Preservation Department – Item 3, LPC-25-09502

**361 Central Park West, aka 1-5 West 96th Street – First Church
of Christ, Scientist, of New York City – Individual Landmark
Borough of Manhattan**

Terrace Guardrail Update

March 19, 2025
Post Approval Amendment

Terrace Guardrail Current Proposed Design: Mesh 6'-0"

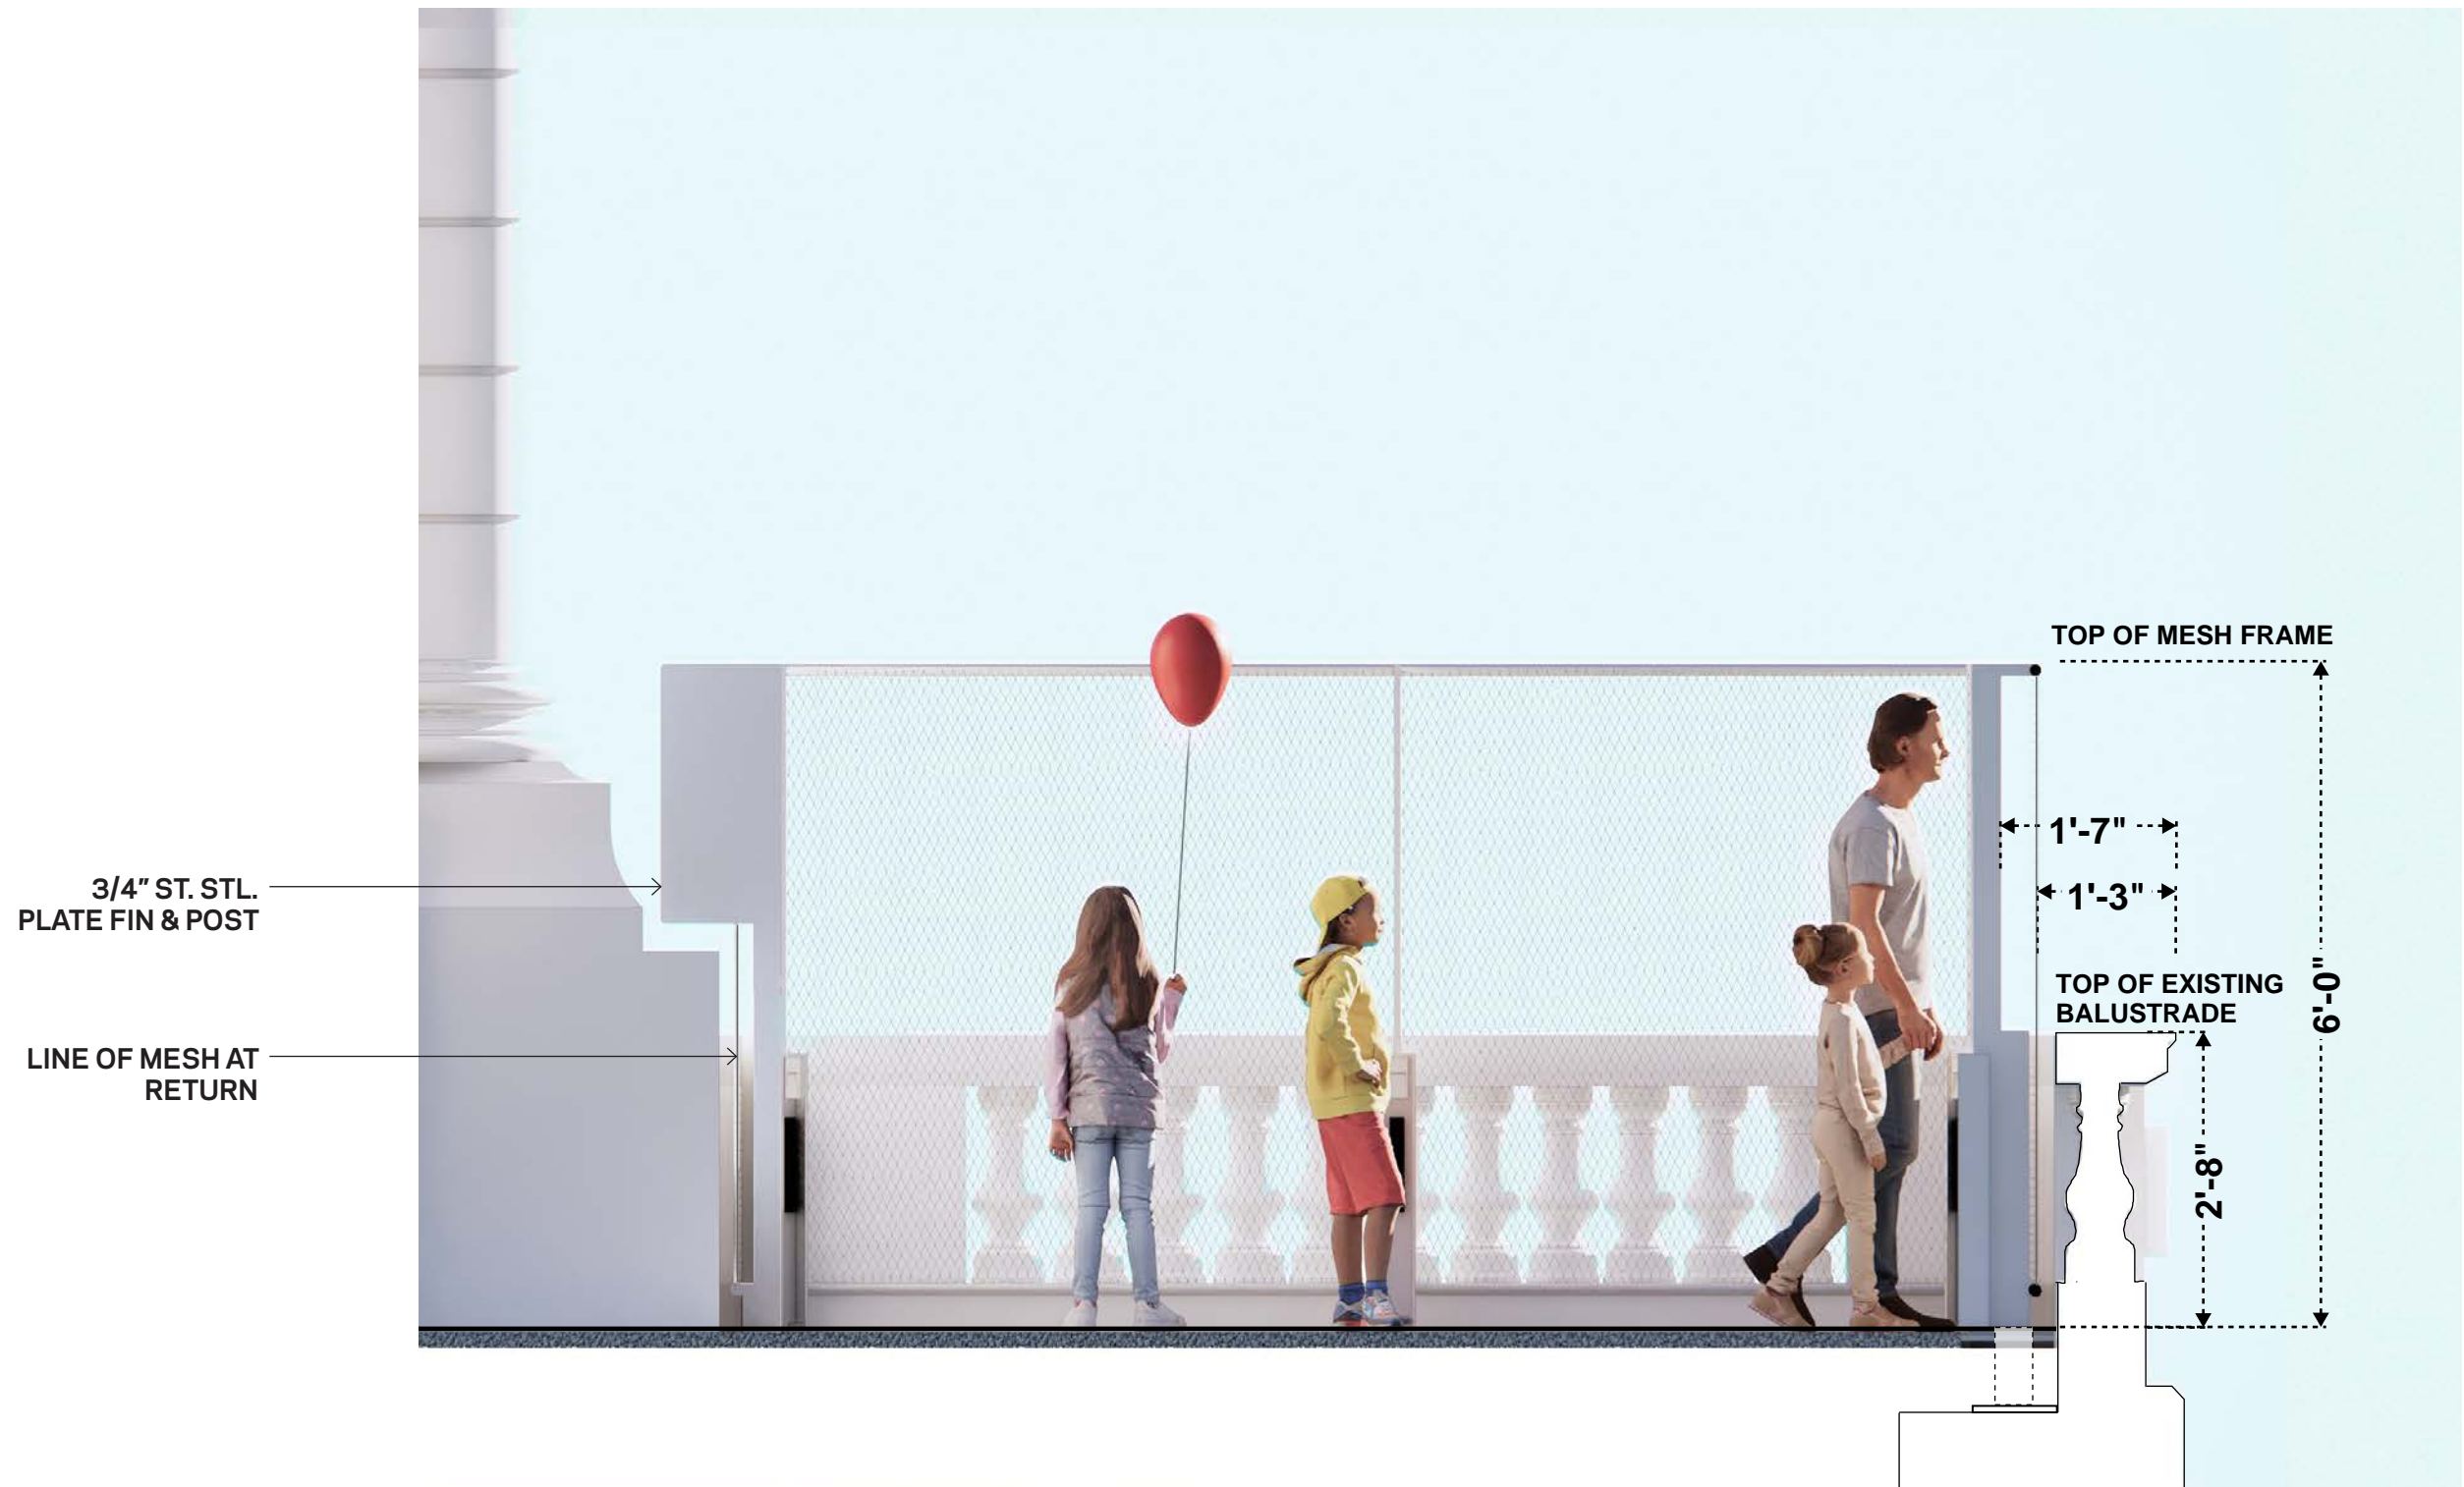
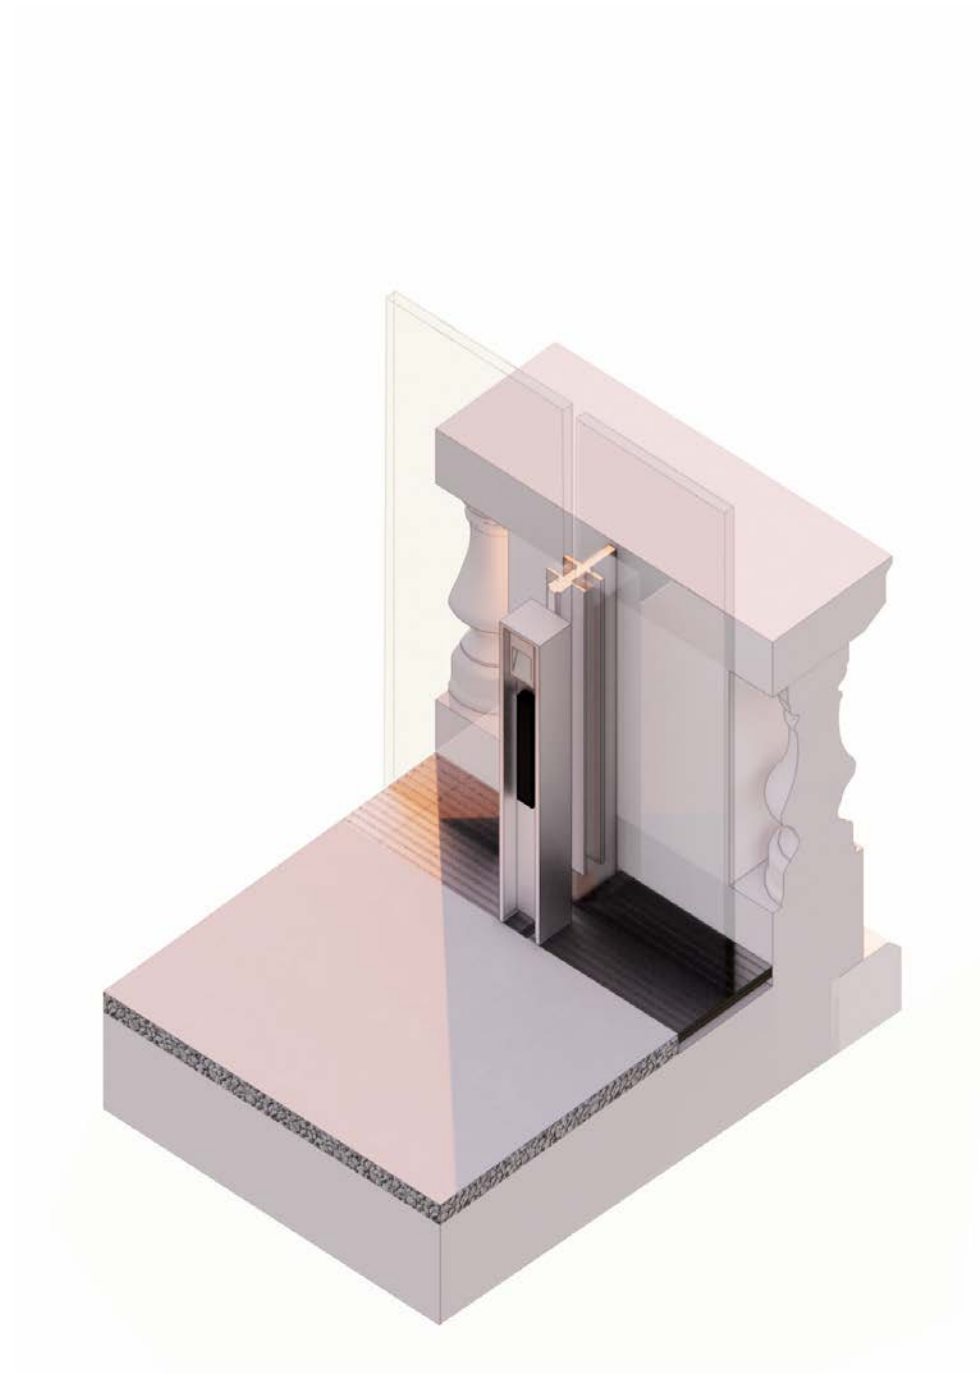
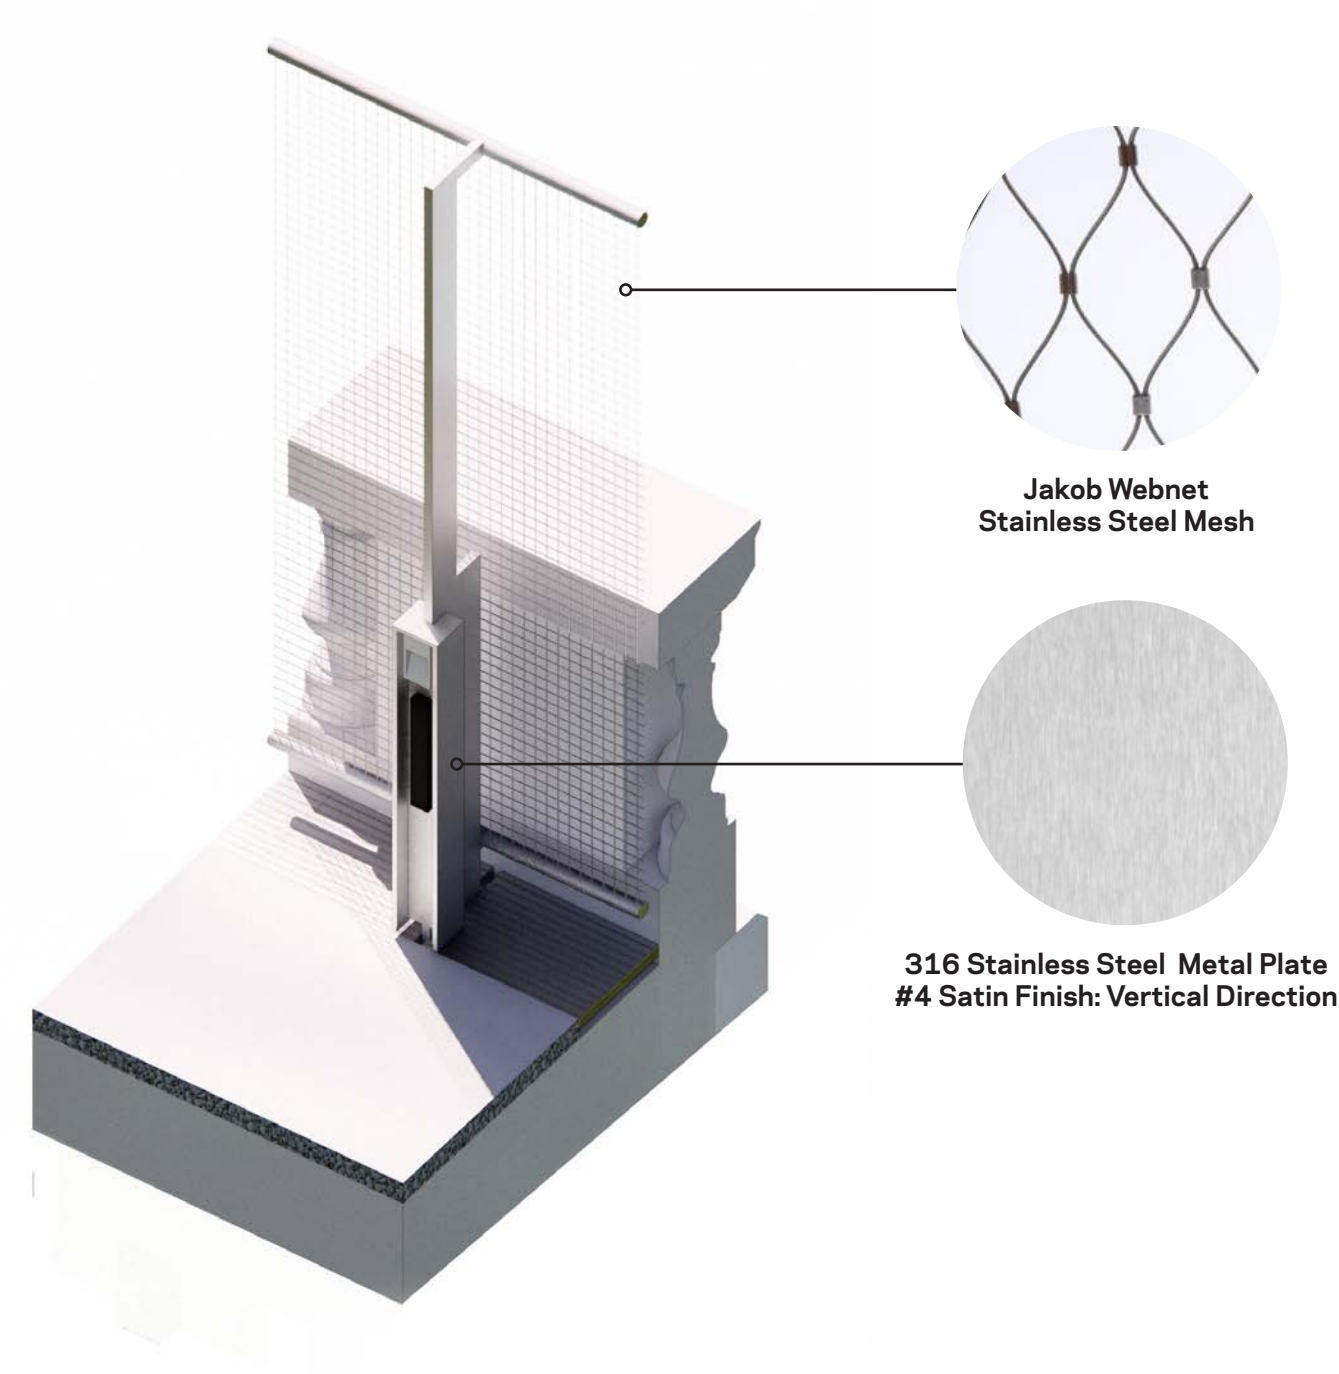
- **Increase guardrail height on the Terrace from 4'-0" to 6'-0" minimum, to address safety concerns**
- **Proposed design includes a stainless steel mesh with minimal frames integrated with the bollards and integrated light standards, simply designed**
- **Mesh is a contemporary intervention, clearly a new element, distinct from the granite tower and balustrade, with small enough apertures to deter climbing**
- **Mesh enhances the visitor experience on roof - feel breeze instead of being enclosed in glass**
- **Mesh is less reflective than glass and safer for birds**
- **Railing at center balcony is removed, a stainless steel frame and mesh gate is added to the center doorway for FDNY access only**

Terrace Guardrail - Bollard Detail

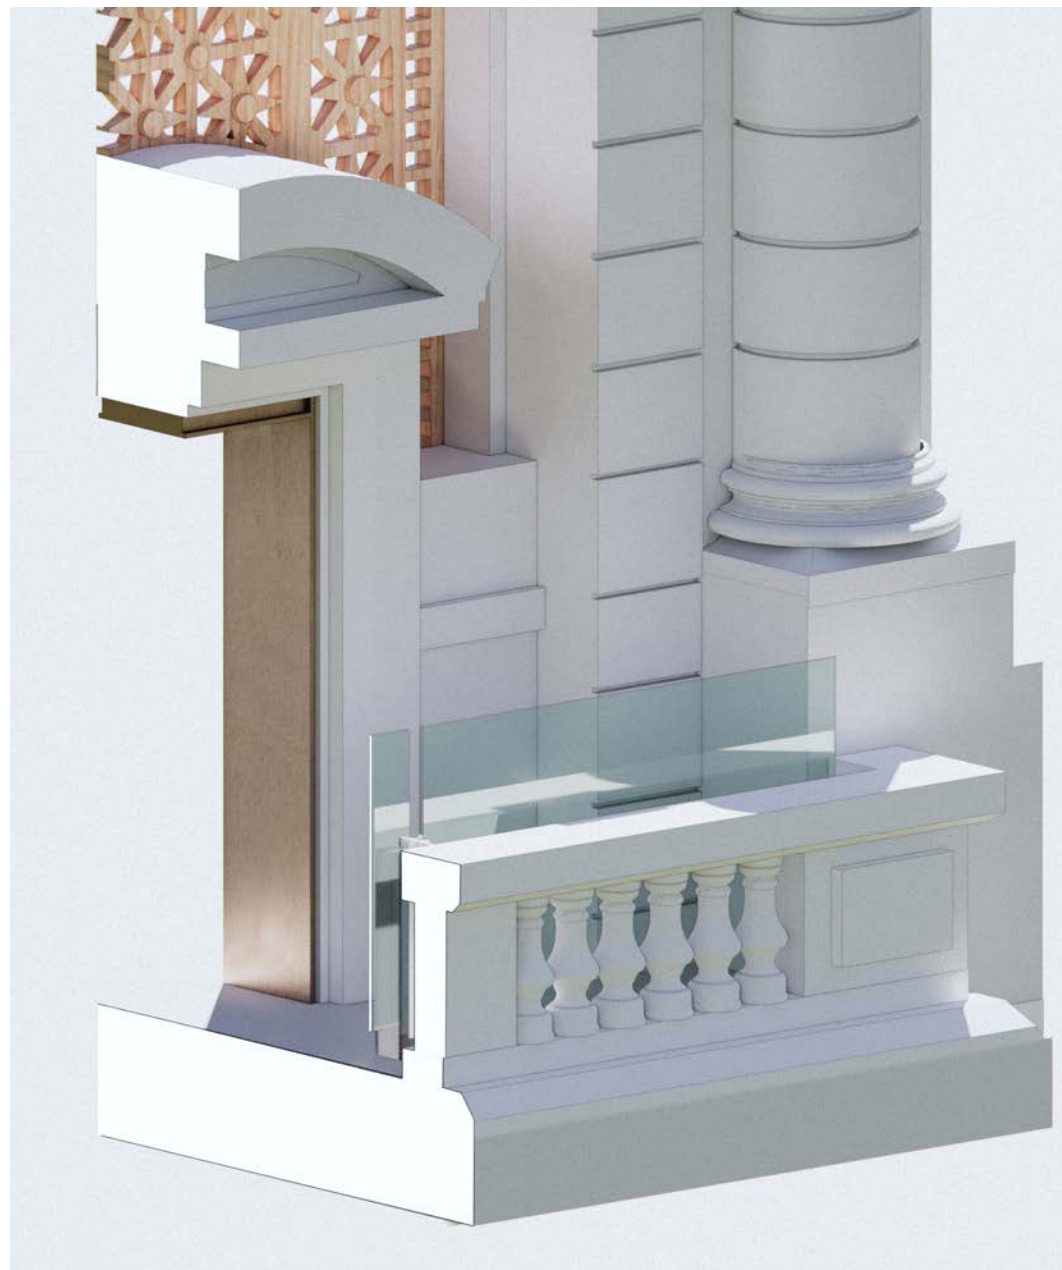
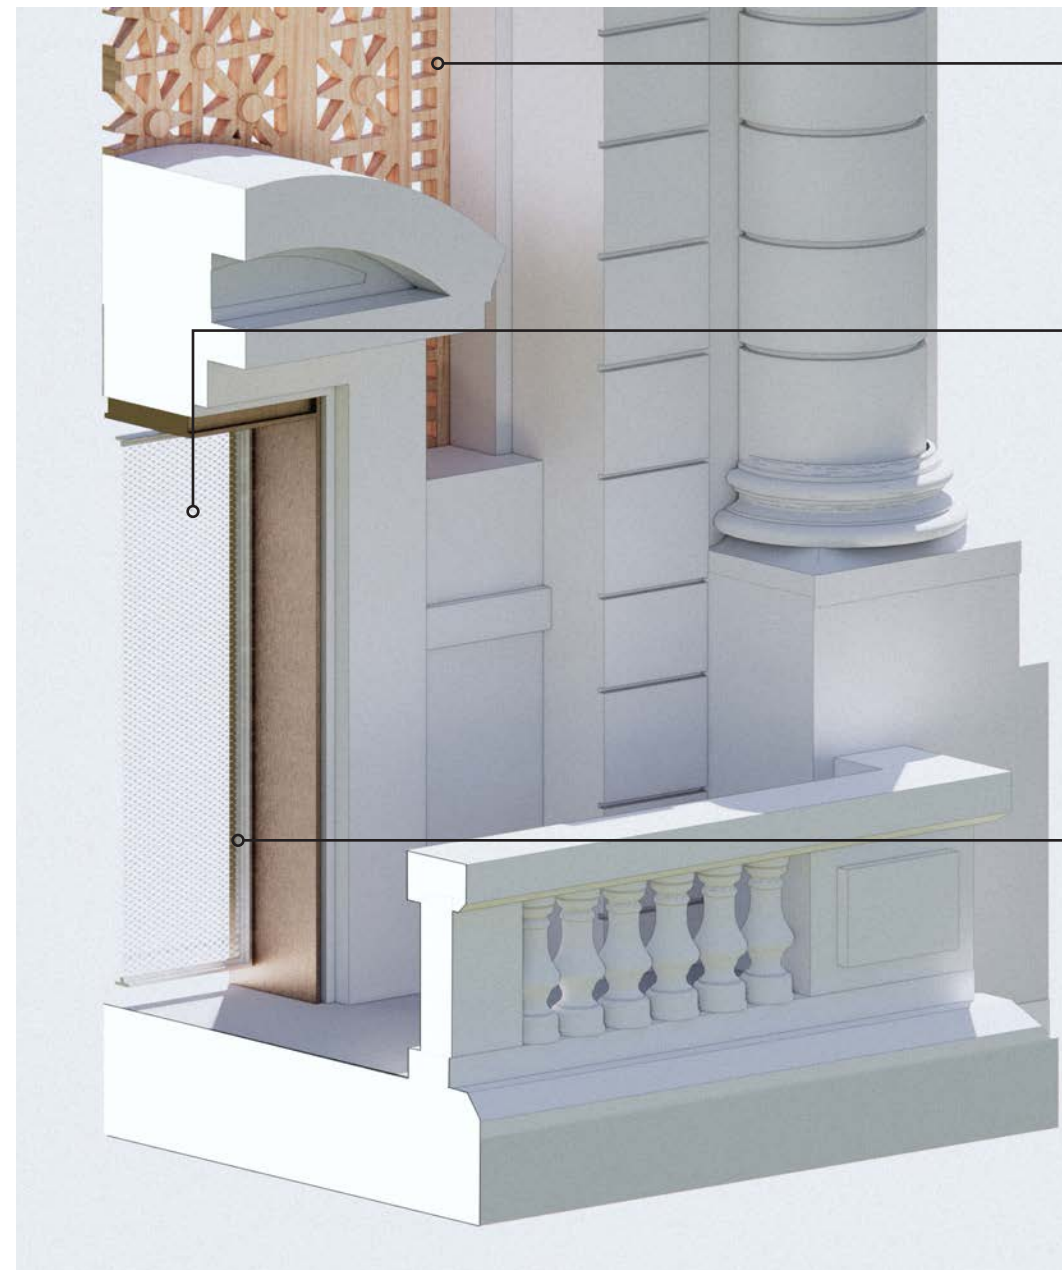
Current Proposed Design - Mesh Gate, No railing
03/19/2025
